Re: Arizona Regional Haze Plan Revision for Cholla Power Plant

On behalf of National Parks Conservation Association and Sierra Club (collectively, the “Conservation Organizations”), Earthjustice respectfully submits the following comments regarding the Arizona Department of Environmental Quality’s (ADEQ) proposed Best Available Retrofit Technology (BART) “reassessment” for the Cholla Power Plant.

Figure 3 Cumulative NOx Emissions Associated with EPA's FIP vs. Cholla BART Reassessment over 2016-2046

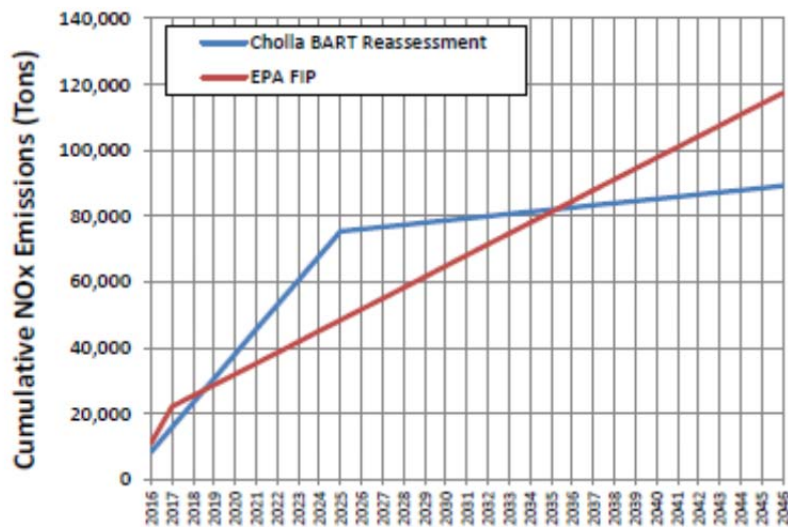
First, the record shows the Cholla BART “reassessment” would increase Cholla’s NOx pollution compared to the existing BART determination.¹⁴ Under the BART “reassessment,” between 2018 and 2025, Cholla would emit *4,161 tons per year more NOx pollution* than it would under the existing BART determination.¹⁵ In addition, the BART “reassessment” would result in greater cumulative NOx pollution for eighteen years after the BART compliance deadline.¹⁶ Figure 3 from ADEQ’s proposal illustrates how the BART “reassessment” would increase Cholla’s NOx pollution by allowing Units 3 and 4 to continue operating for the next ten years without installing additional pollution controls.¹⁷

As the Ninth Circuit recently stated, it would not be “difficult[.]” to show a section 110(l) violation if an existing implementation plan unambiguously required a certain level of pollution reductions, and a plan revision would result in more pollution. *El Comite Para el Bienestar de Earlimart*, 786 F.3d at 696 (“The difficulty with [the] argument” that a revision weakened an existing plan’s 20% pollution reduction requirement, is that the existing plan “is ambiguous, because it refers to both a 12% reduction and a 20% reduction.”). But this is exactly what would occur under the BART “reassessment,” as Arizona’s new BART determination would result in an additional 4,161 tpy of NOx pollution for more than seven years after the BART compliance deadline. Moreover, when Cholla’s cumulative NOx emissions are considered, the BART “reassessment” would result in increased pollution levels until 2035, which is nearly two decades after the BART deadline.

Figure 6 Comparison of Integrated Visibility Impacts at Petrified Forest National Park Associated with EPA FIP vs. Cholla BART Reassessment

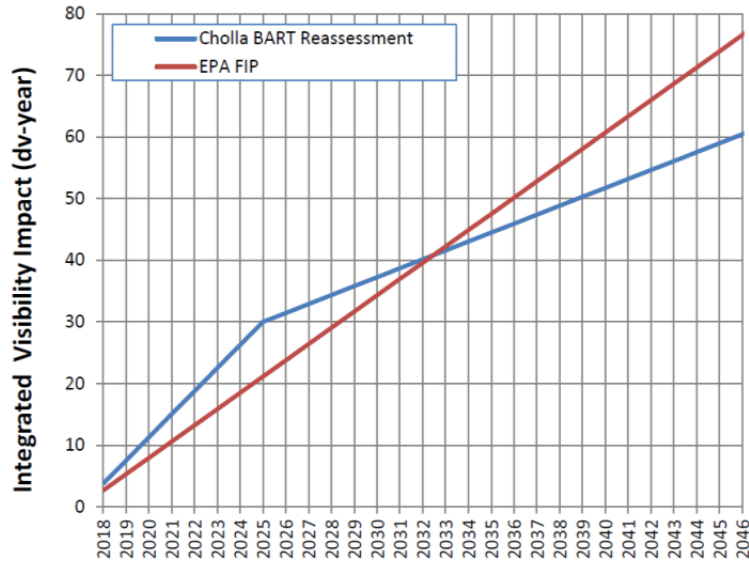
Second, the record also shows the BART “reassessment” would worsen air quality because it would result in worse visibility conditions than the existing BART determination. The existing BART determination will provide significant visibility benefits beginning immediately after the December 2017 compliance deadline. But for several years after that compliance deadline, the BART “reassessment” would result in worse visibility conditions at Class I areas compared to the existing BART determination.¹⁸ For example, Cholla’s air pollution causes the greatest visibility impairment at Petrified Forest National Park, which is the closest Class I area. As Figure 6 to ADEQ’s proposal shows, Cholla’s visibility impacts at Petrified Forest would be worse under the BART “reassessment” for fifteen years after the BART compliance deadline.¹⁹

Figure E-2: Plot of Predicted Cumulative Visibility Impacts at Grand Canyon National Park Associated with EPA FIP (red) vs. Proposed BART Reassessment (blue)

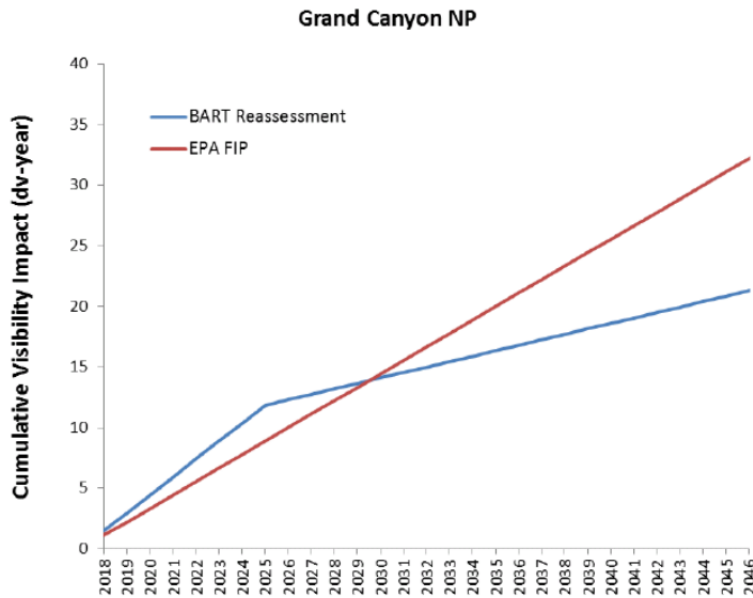
The situation is similar at the Grand Canyon. As Figure E-2 to ADEQ’s proposal shows, Cholla’s visibility impacts at the Grand Canyon would be worse under the BART “reassessment” for twelve years after the BART compliance deadline.²⁰ Furthermore, ADEQ acknowledges that this same “general pattern” of worse visibility impacts under the reassessment holds true at the other Class I areas impacted by Cholla’s air pollution.²¹
